SERVICE BULLETIN

CK-SB010

SUBJECT: ENGINE COOLANT LINE ROUTING

MODELS AFFECTED: All CCX-1865-1001 THRU CCX-1865-1007

Figure 6 - COOLANT TUBE VS PUSH-ROD TUBE

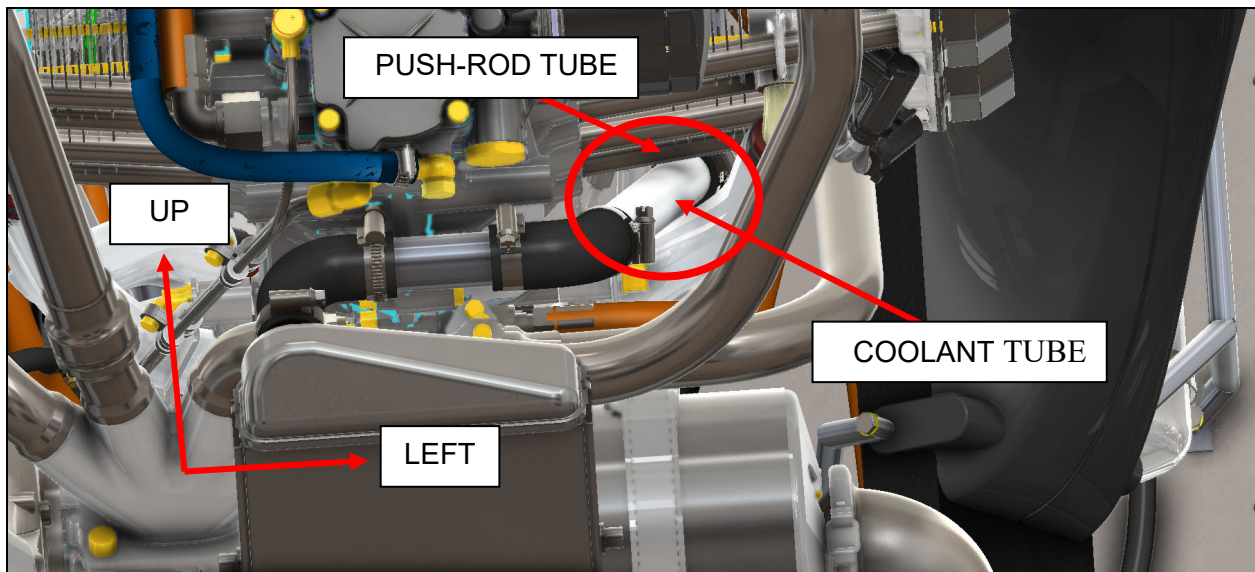
5. Inspect aluminum tube segment where it passes below cylinder, looking where chafing may have occurred between the tube and the engine pushrod tube. In addition, ensure that stainless steel hose clamps securing silicone coolant elbow fittings are positioned in such a way as to avoid chafing on any components.

6. If no chafing is evident, proceed to Step 8.
7. If chafing is evident on the coolant tube and/or on the push-rod tube sufficient to expose raw material, contact CubCrafters Customer Support. Depending on extent, the coolant tube may require replacement.

Figure 7 - RTV LOCATION

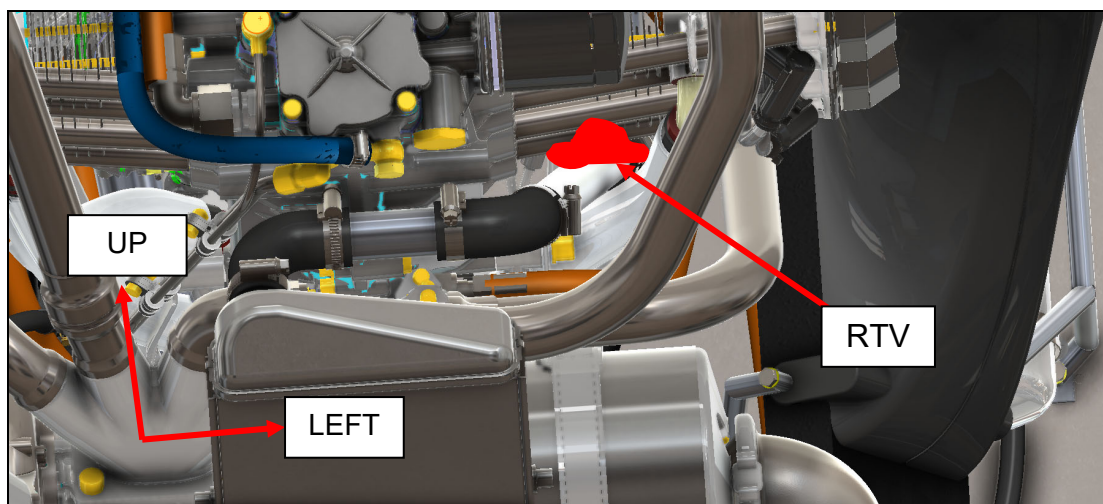
8. Wrap the section of coolant tube in close proximity to the engine with RM1074-001 (silicone tape), then apply a generous daub of RM0013-002 (RTV), supporting the radiator as near as possible to final installed condition until the RTV is cured.
